Public Correspondence

**VOLCANO HEIGHTS
CONCEPTUAL DRAINAGE COMPILATION PLAN**

Volcano Height Sector Plan: Character Zones

9.4.2 Neighborhood center

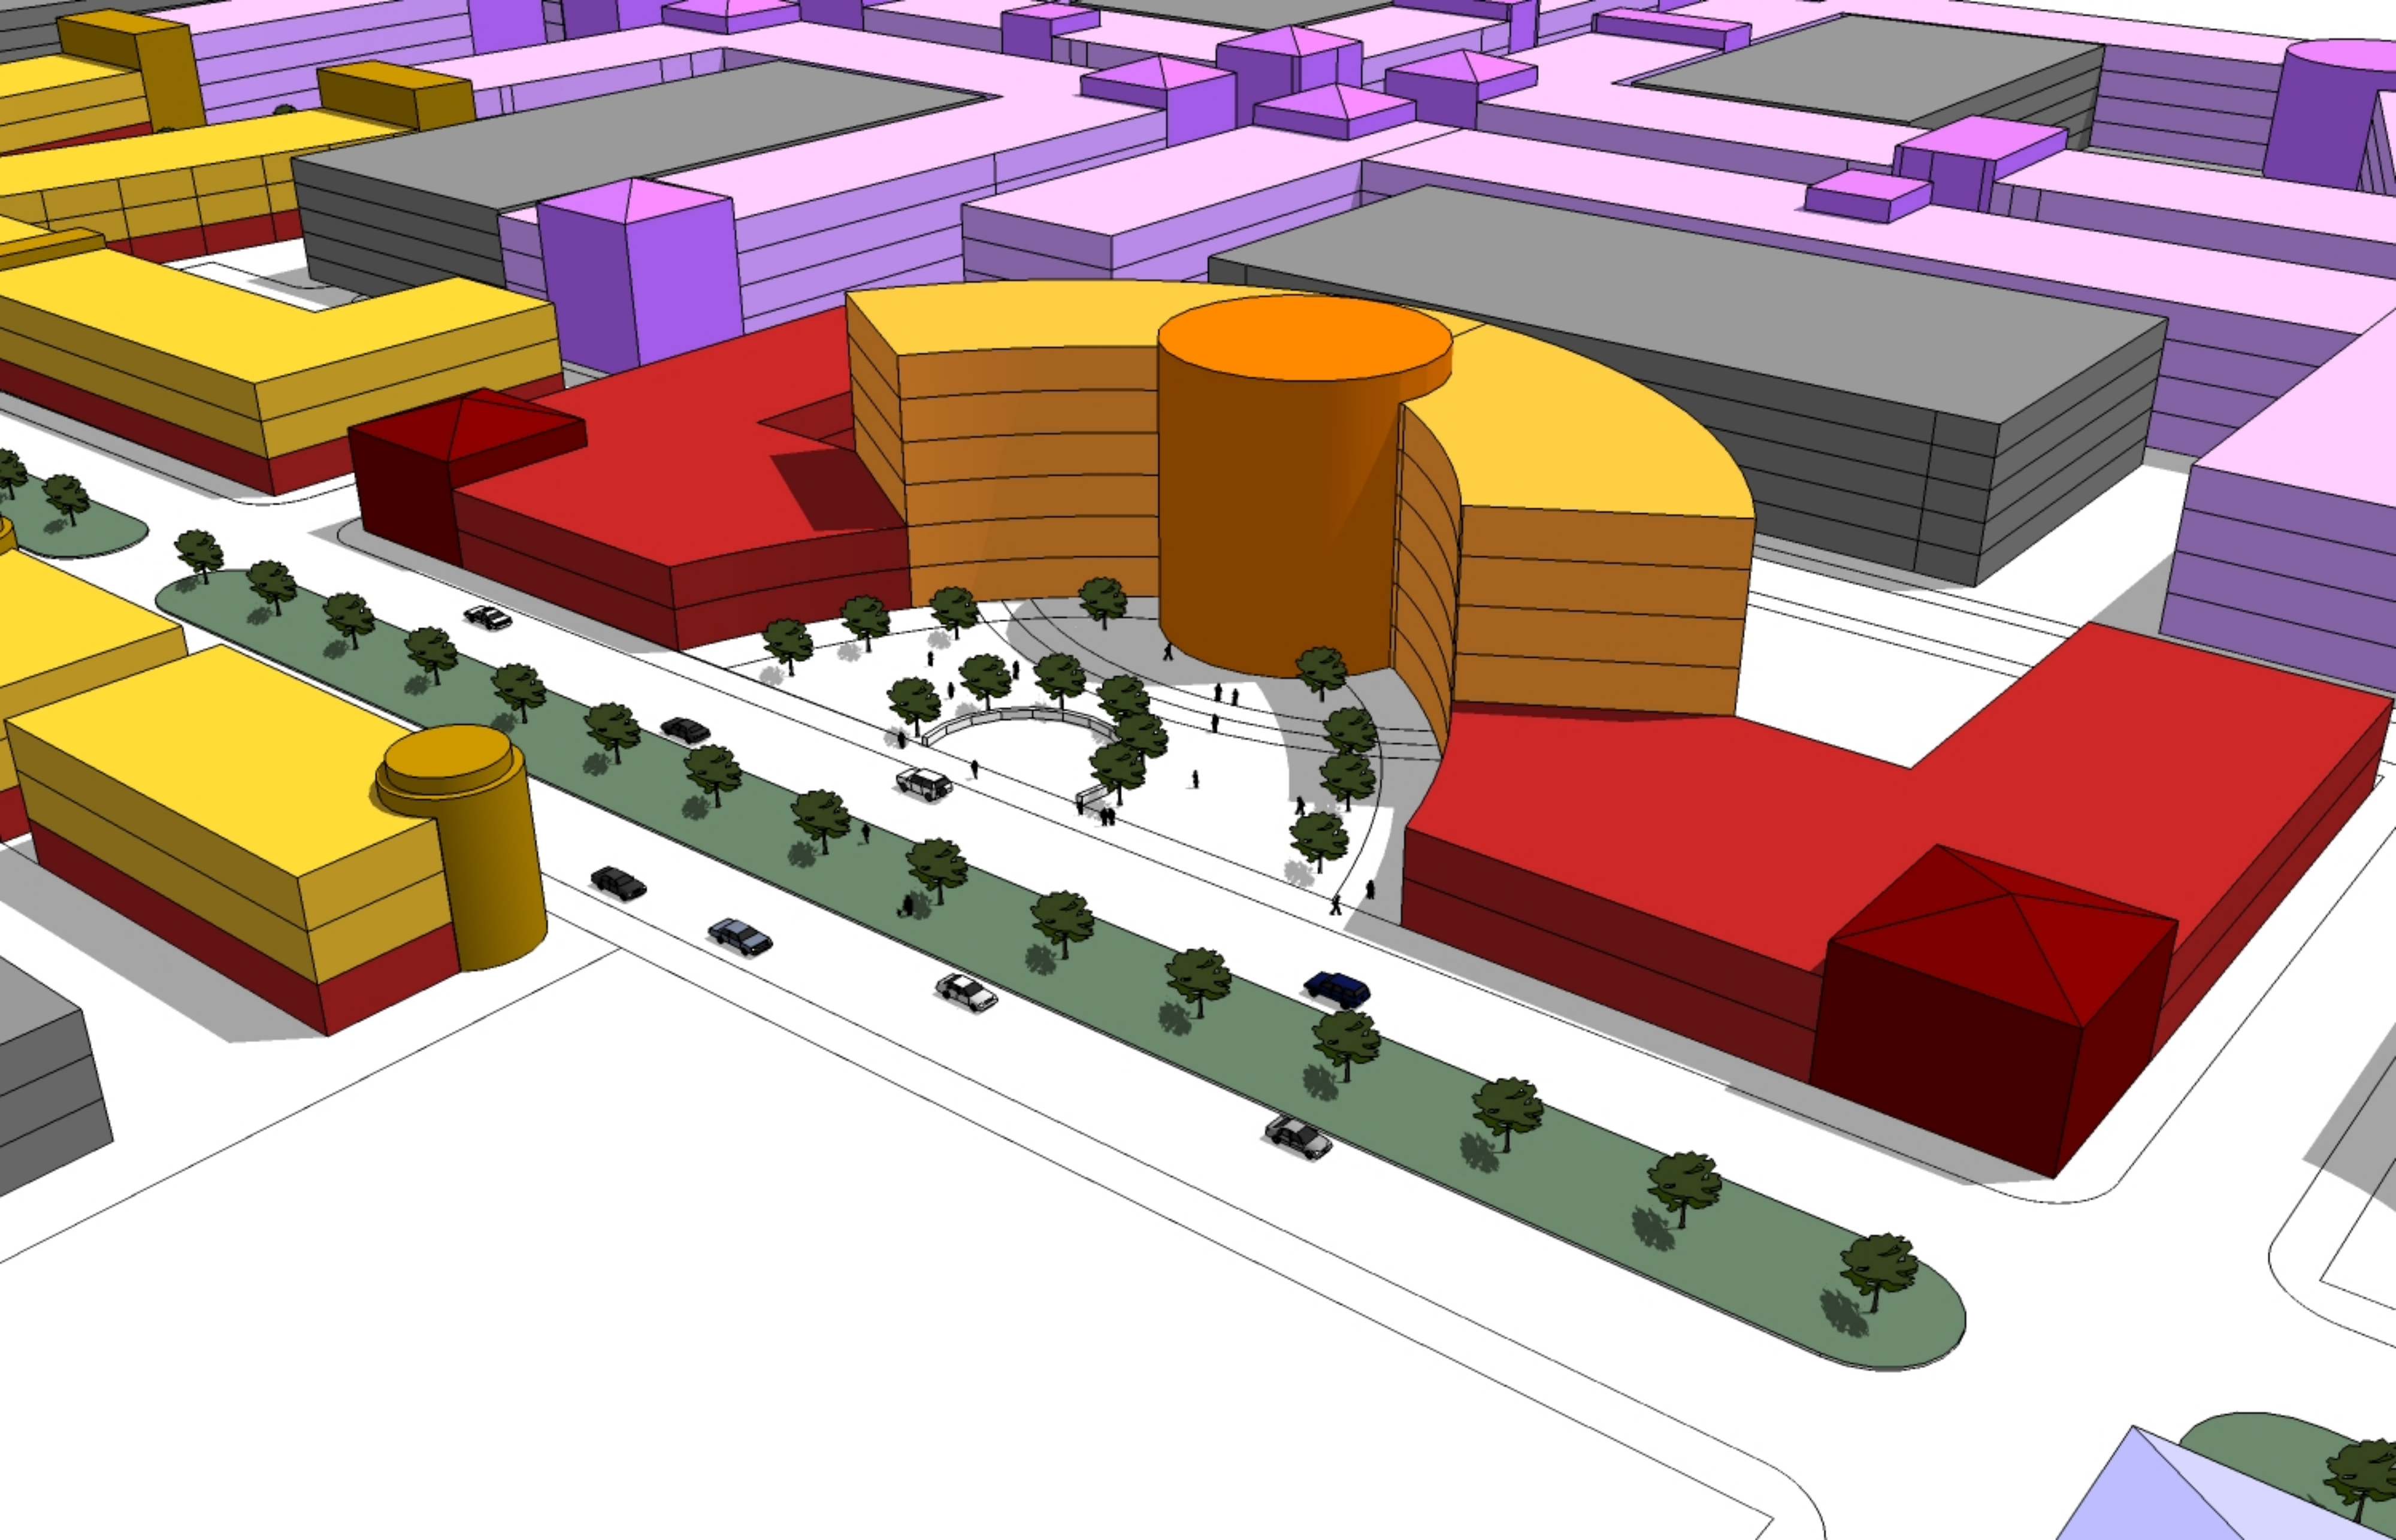
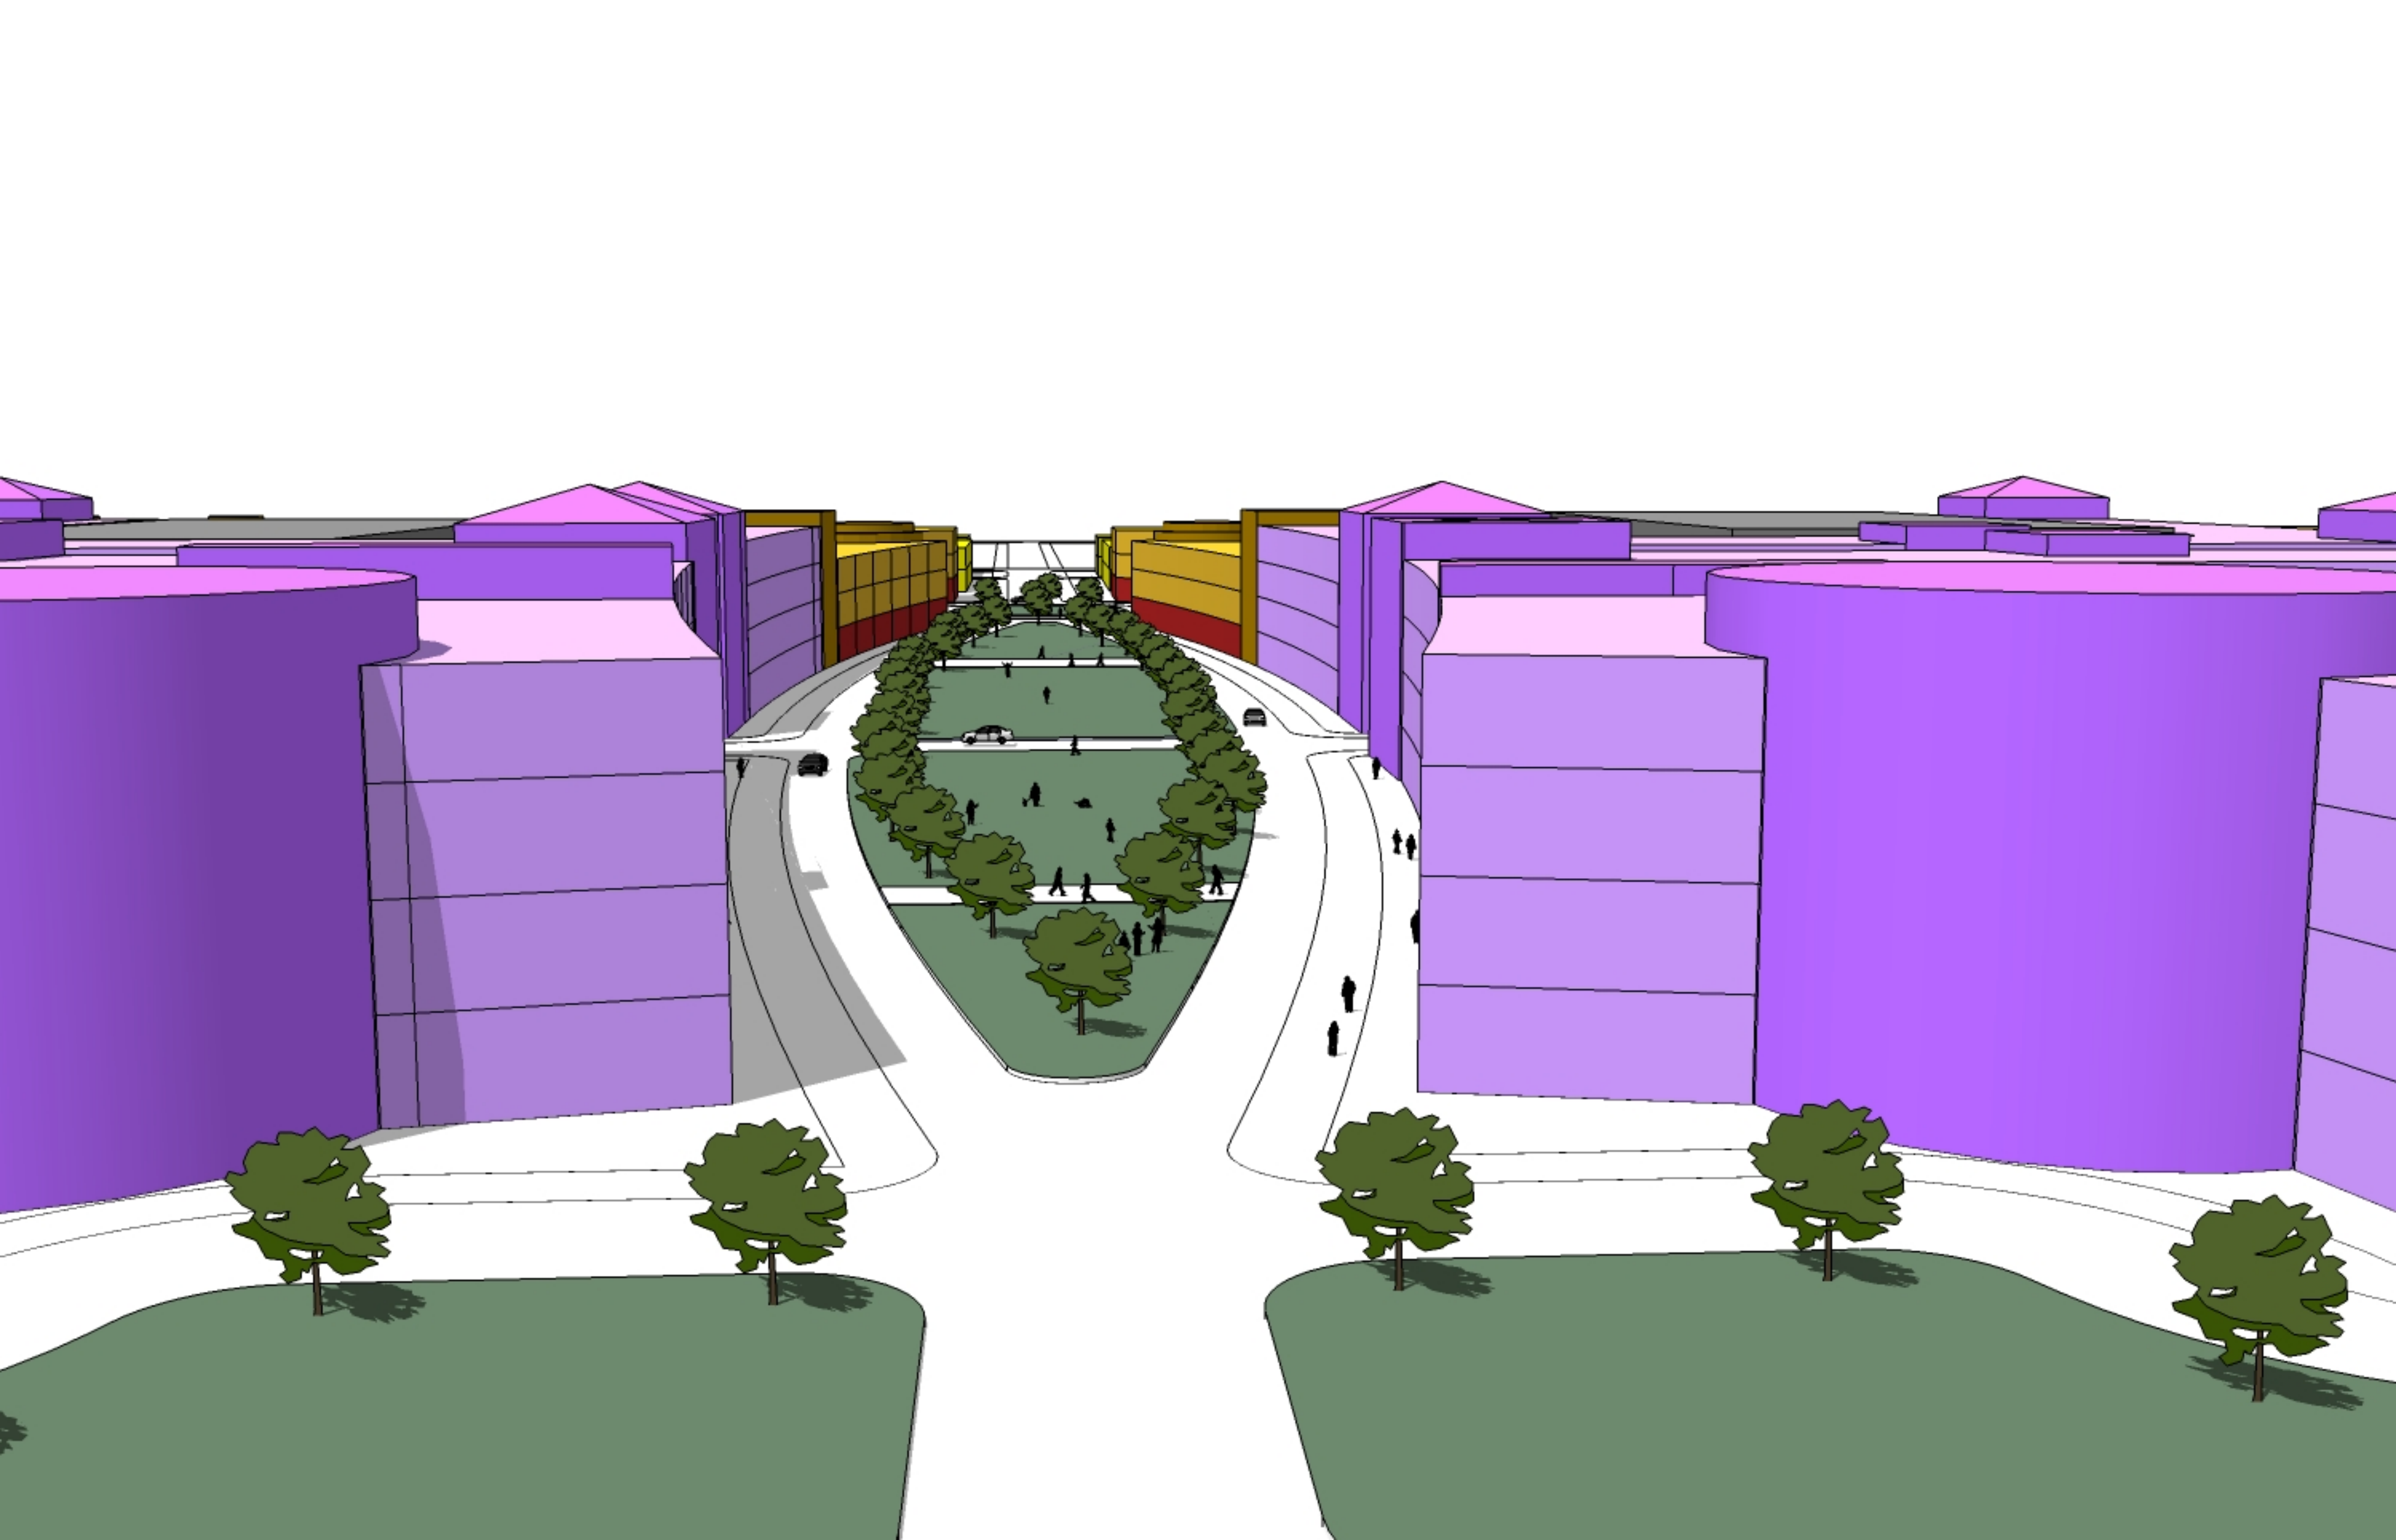
What good is a 3' high fence? Any person or most dogs can get over it easily. Wind blown rubbish will collect at it. Transients will sit on it.
